BULLETIN: CA-SB-19-C-64-22

SERVICE BULLETIN

ANTI - RECYCLE TIMER CIRCUIT

To forward information concerning the anti-recycle timer circuit, the 19C8 machine oil pump time-delay relay, and a change in the 2CR relay.

Figure 2

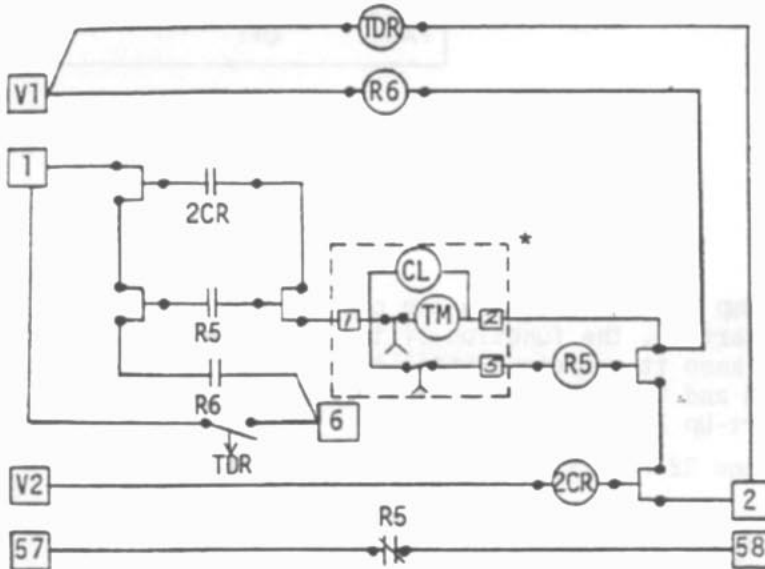
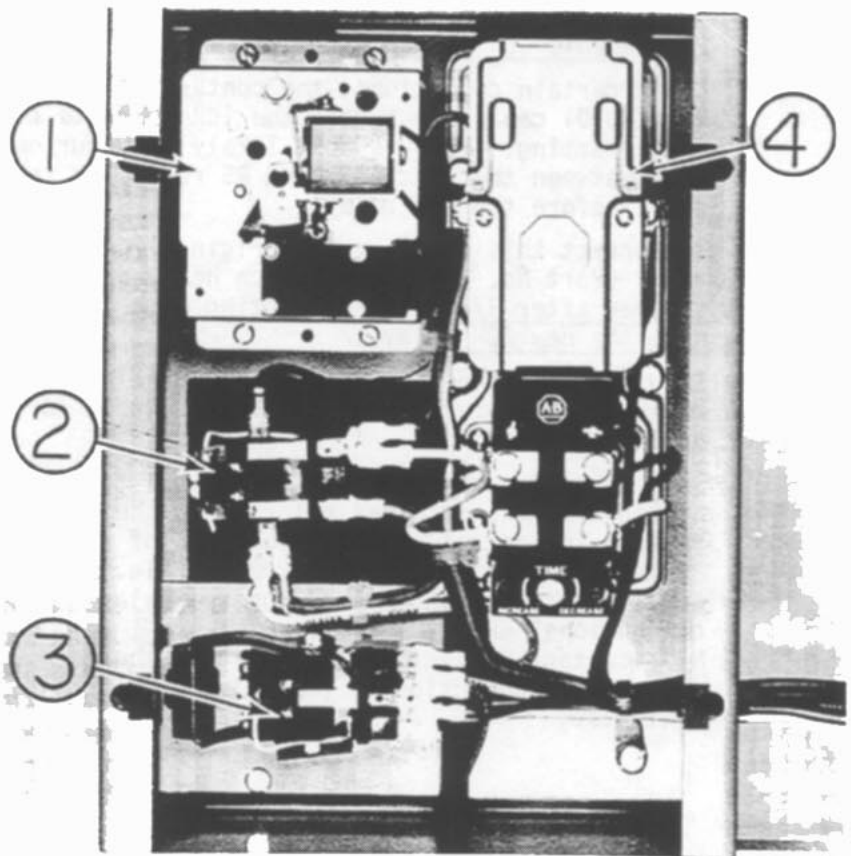
On 19C8 machines, the R6 relay has a time-delay feature which is actually a time-delay relay (TDR) wired in parallel with the R6 relay (see Fig. 2). When the Stop button is pressed, the time-delay relay remains energized for three minutes, keeping the oil pump running for that time during compressor coastdown.

ORIGINAL 2CR RELAY
PART # HN61ZJ-010

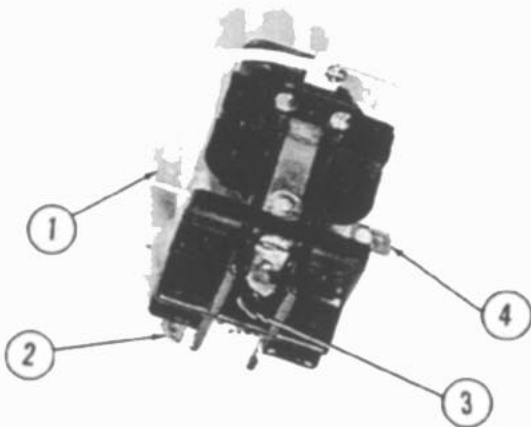
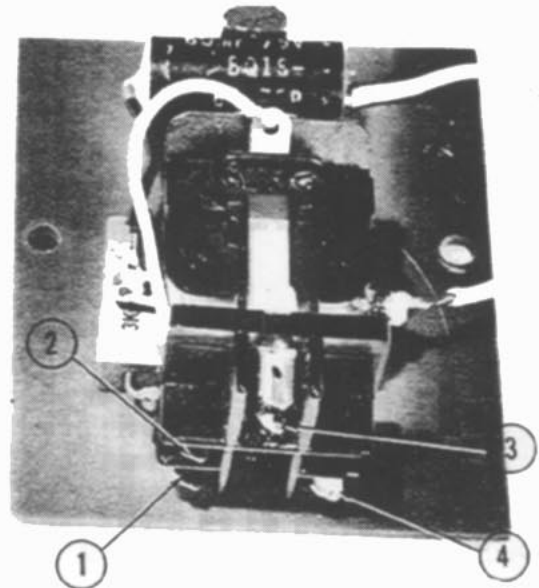
Under certain conditions, the contacts of the original 2CR relay (Part No. HN61ZJ010) can close before the ICR contacts close, preventing the machine from starting. This is most likely to occur on machines where the response time between the 2CR, ICR, and R5 relays is such that the R5 relay energizes before the ICR relay.

Schematically, the wiring is identical for both relays. The wires disconnected from the original relay go to their equivalent terminals on the new relay. The actual physical location of the terminals on the two relays is different. The original 2CR relay (Fig. 3) and the new 2CR relay (Fig. 4) are shown for comparison purposes. Relay connections ① and ④ (the coil connections) are wired to Terminals V₂ and 2. Relay connection ③ (the N.O. contact connection) is wired to the R5 N.O. contact and to Terminal 1. Relay connection ② (the common connection) is wired to the R5 common contacts.

To correct this problem, the original 2CR relay has been replaced with a relay (Part No. HN67ZJ115) which has a built-in time delay. All consoles shipped after 9/30/63 and starting with Console Serial No. 70254 and higher have the new 2CR relay.

It is recommended that the HN61ZJ010 relay be replaced with an HN67ZJ115 relay when start-up problems, attributable to the original 2CR relay, are experienced.
